MAX32630 ERRATA SHEET

Revision A1 Errata

10) SPI MASTER INTERBYTE DELAY IN MODE 0

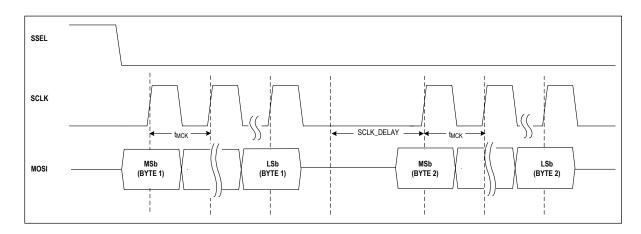
The SPI master remains low one or more SCLK cycles after transmitting 8 bits of data, resulting in an interbyte delay when transmitting back-to-back bytes. This erratum does not affect the integrity of the synchronous SPI bus because no data is clocked in or out by the SPI slave during the delay time SCLK is asserted low.

In single mode, the delay occurs after SDIO[0] has transmitted all eight bits.

In dual mode, the delay occurs after SDIO[1:0] have each transmitted four bits.

In quad mode, the delay occurs after SDIO[3:0] have each transmitted two bits.

The length of the delay is a function of the SPI clock frequency as shown in the following table. The SPI master must be operated in sample mode with a maximum frequency of 24MHz.

None.
